June 1996

TECHNICAL SUPPORT FOR PROPOSED  
MODIFICATION TO THE CHURCH ROCK SITE  
TAILINGS RECLAMATION PLAN  
NRC LICENSE SUA-1475

REVISION 1

United Nuclear Corporation

PROPOSED AMENDMENTS TO  
FINAL RECLAMATION PLAN  
SOUTH END  
PREPARED FOR

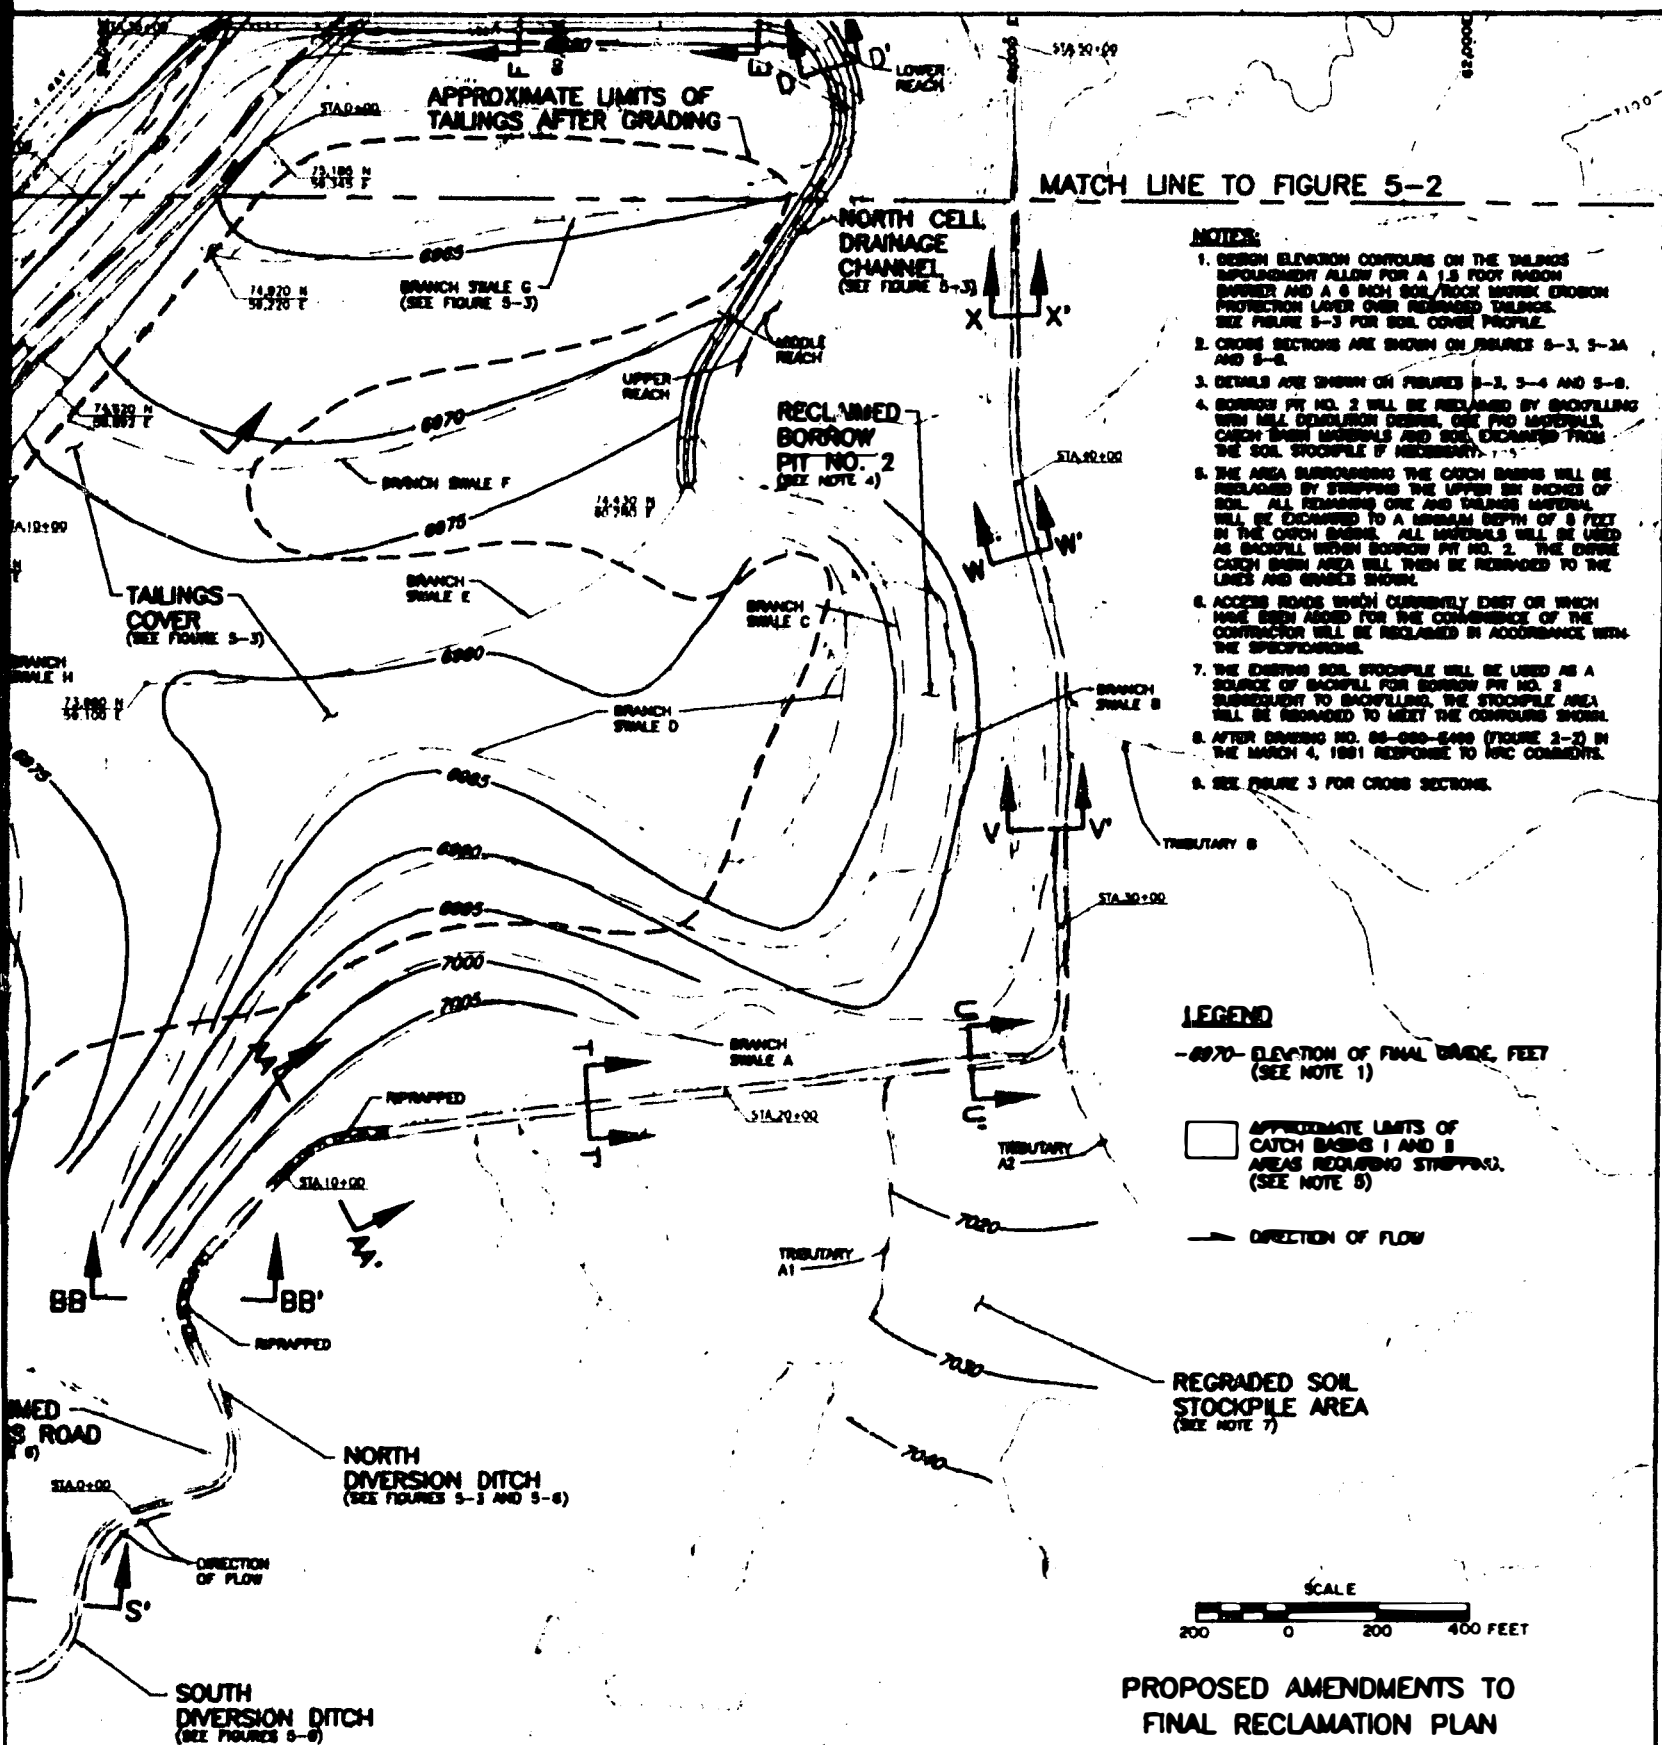
It is proposed that recontouring plans for the area south of the buried jetty and west of the South Tailings Cell be altered. Instead of recontouring the entire area between the South Cell and the Pipeline Arroyo, the existing surface features will remain in place. The existing surface drainages will be cleaned out and regraded as necessary to ensure positive drainage parallel to the face of the tailings pile until the channels discharge into the Pipeline Arroyo.

This proposed modification addresses regrading of the area shown on Figure 1, which is located west of the reclaimed tailings disposal area and south of the Buried Jetty. The engineered contours require that a large volume be moved. These contours were developed to promote positive drainage away from the tailings area. However, review of the existing surface features indicates that the existing roadways and natural drainage channels actually provide equal or better long-term protection for the tailings. The existing surface features direct runoff into flow paths parallel to the face of the tailings, thus inhibiting the development of headward erosion toward the reclaimed tailings pile.

Figure 1 shows that the engineered contours required by the Reclamation Plan result in a smooth slope from the tailings to the Pipeline Arroyo. As shown on Figure 2, this area is currently occupied by two roadways and portions of a toe dam which was built in 1979 to protect the tailings impoundment. These features, with the runoff control ditch, produce a drainage pattern that results in several small channels directing runoff parallel to the face of the tailings pile. These channels flow southwest to discharge into the Pipeline Arroyo.

Also, the depression located south of the South Cell Drainage Channel (SCDC), highlighted on Figure 1, will be backfilled with material excavated from the SCDC. The backfill will be contoured to maintain the natural drainage toward the SCDC and the Pipeline Arroyo.

It is proposed that the existing roadways and drainage channels be left in place. The channels will be cleaned out, and any existing obstructions will be removed to ensure that positive drainage exists along the entire length of each channel. The upper ends of the drainage channels adjacent to the buried jetty will be regraded as necessary to maintain a gradual slope from the top of the buried jetty to the channel bottoms.

SURFACE PROFILES

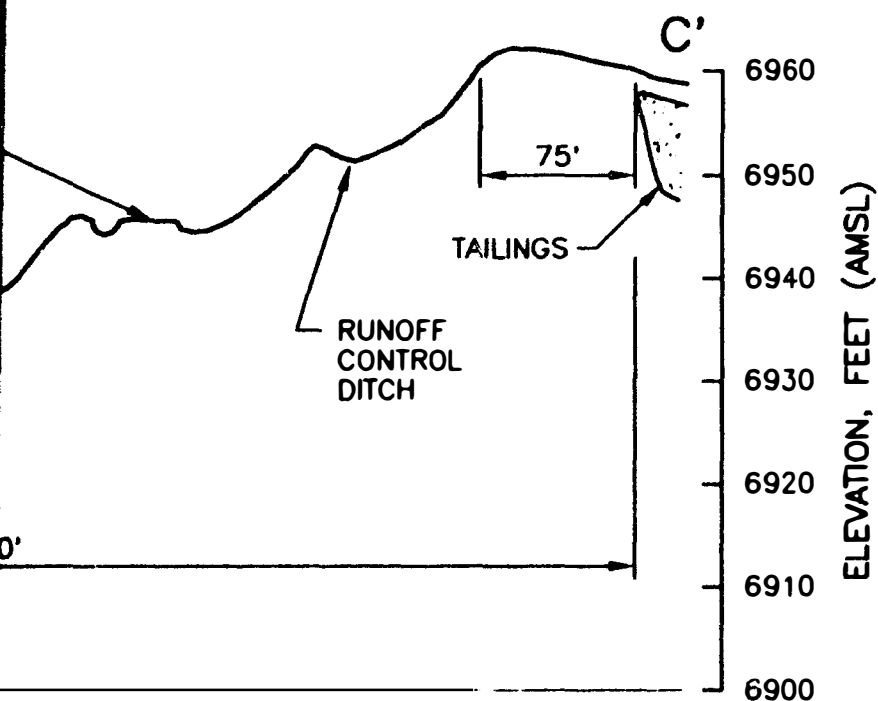
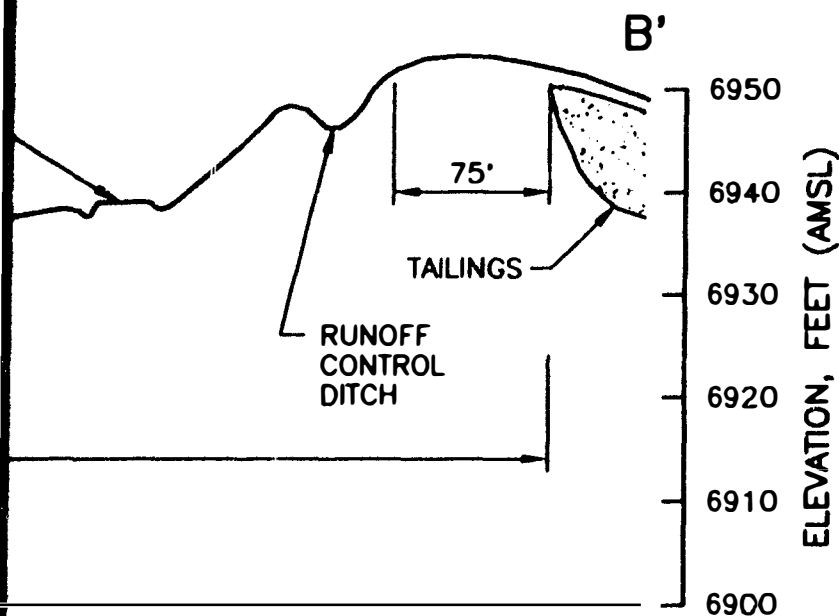
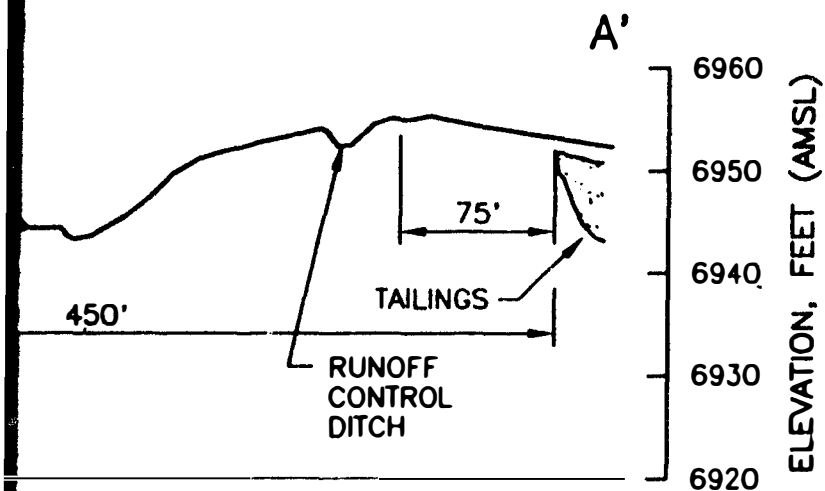
The existing channels have a beneficial effect because, by promoting flow parallel to the tailings embankment, headward erosion into the tailings and the development of gullies in the reclaimed cover is inhibited. Figure 3 shows a series of surface profiles which illustrate that the existing surface features produce a terraced effect, which slows and breaks up flow off the tailings embankment. The surface profiles also show that the probable maximum flood (PMF) flow is entirely contained in the channels farthest from the tailings and within the Pipeline Arroyo beyond a point about 300 feet southwest of the buried jetty. An additional safety factor is provided by the fact that the closest

DRAWING NUMBER 86-060-E544

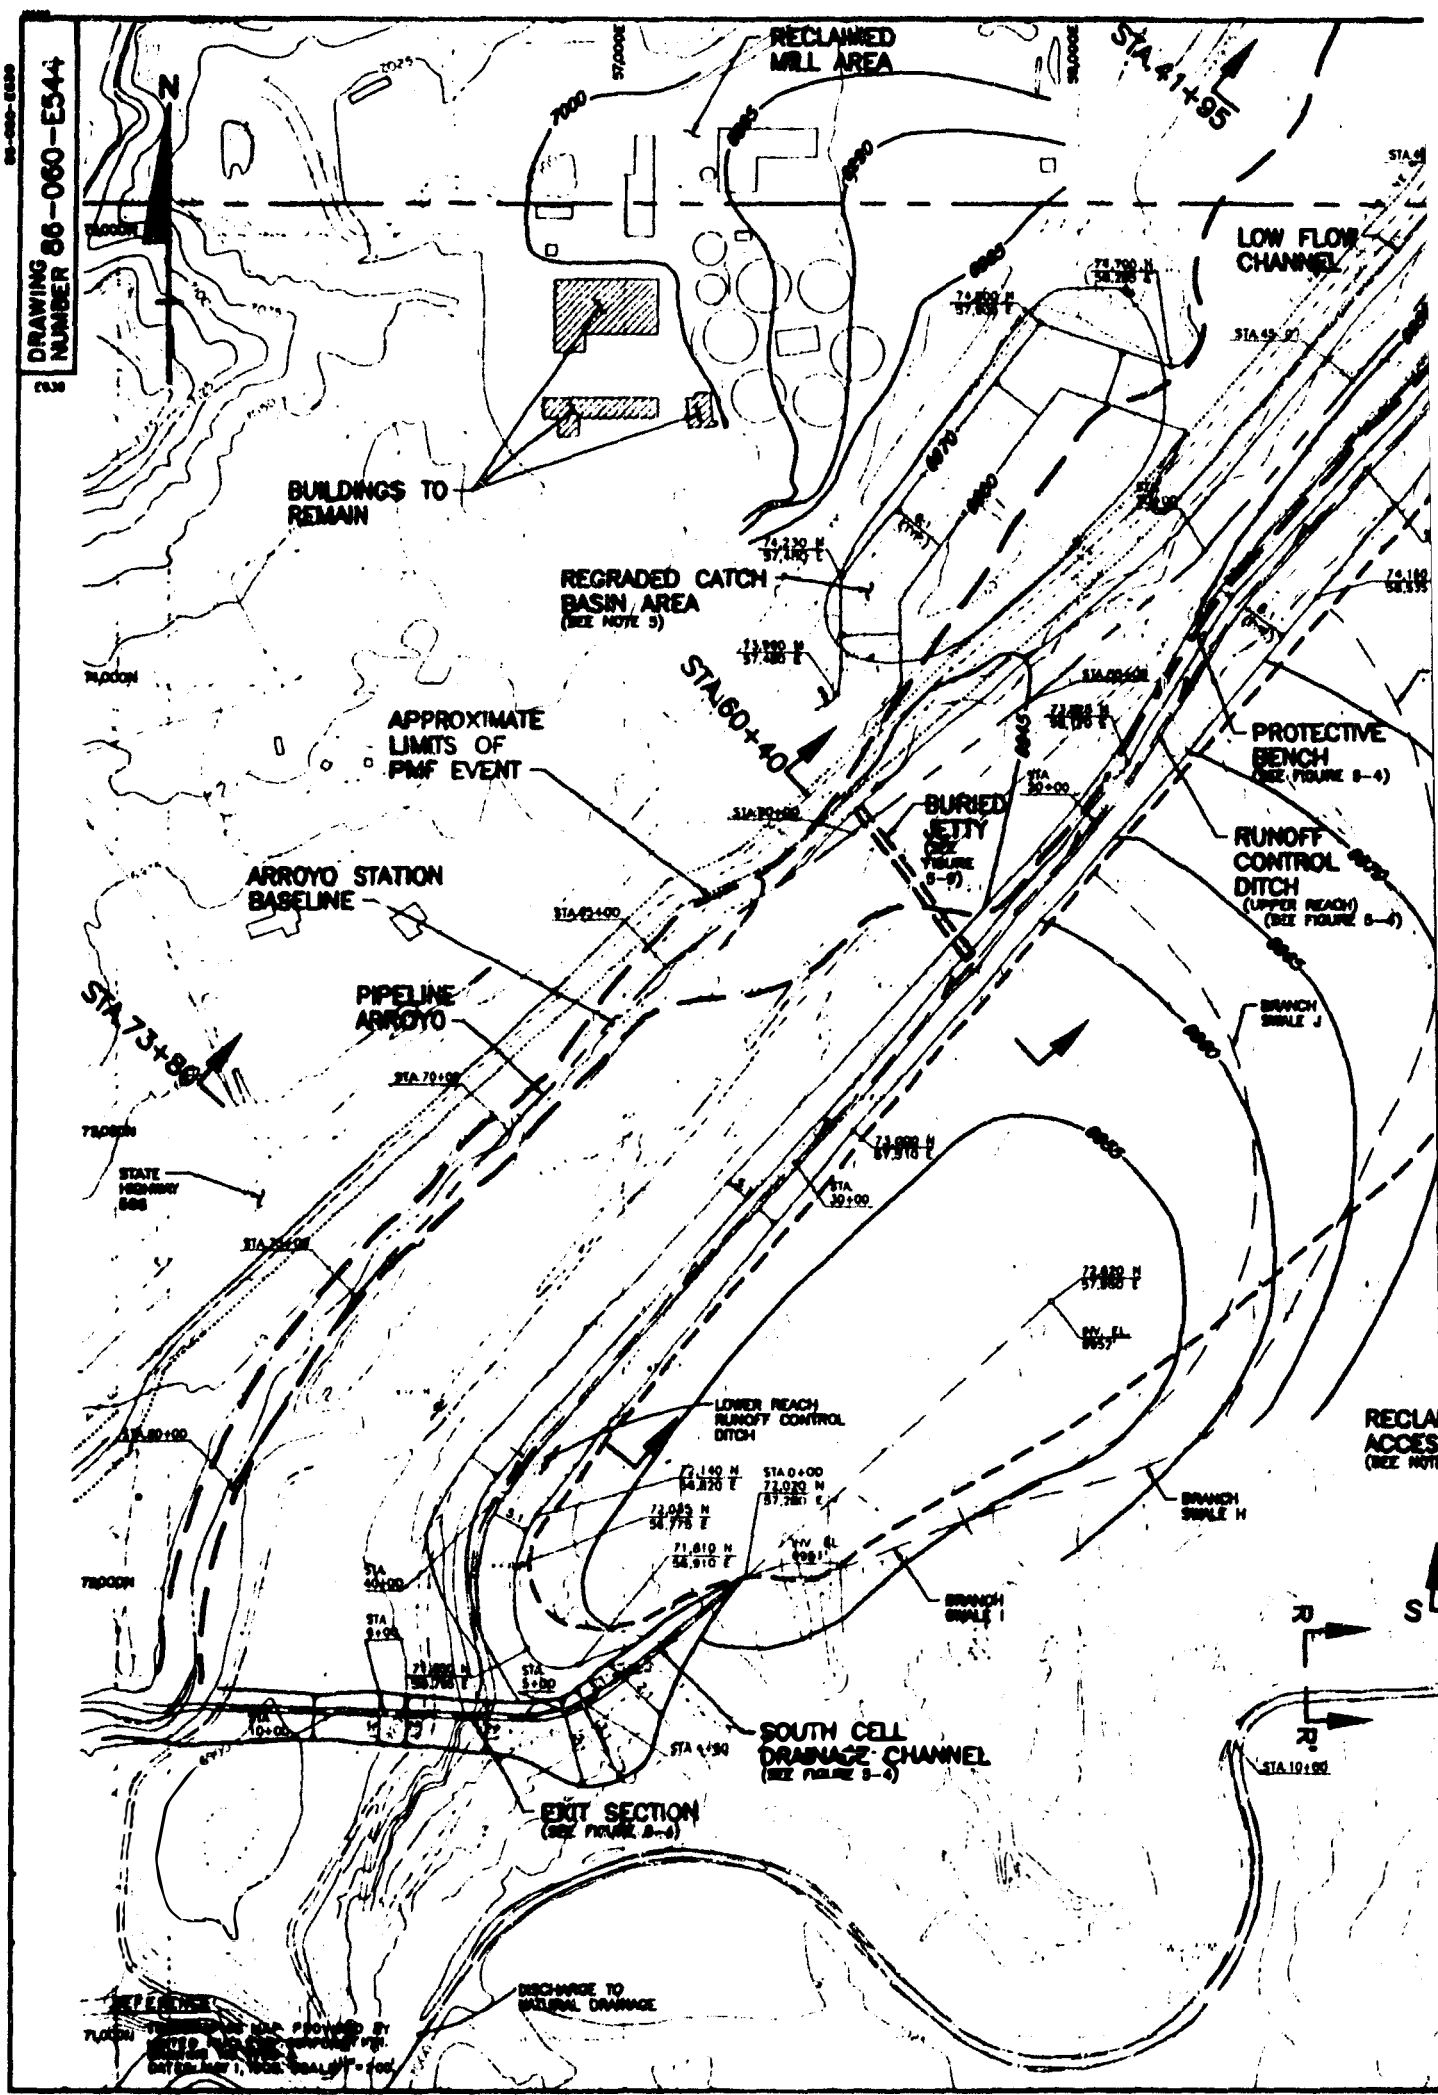
A revised Figure 5-1 is included as an attachment. The engineered contours for the area under discussion (shown on the original figure) have been removed, indicating that the existing contours will be left in place.
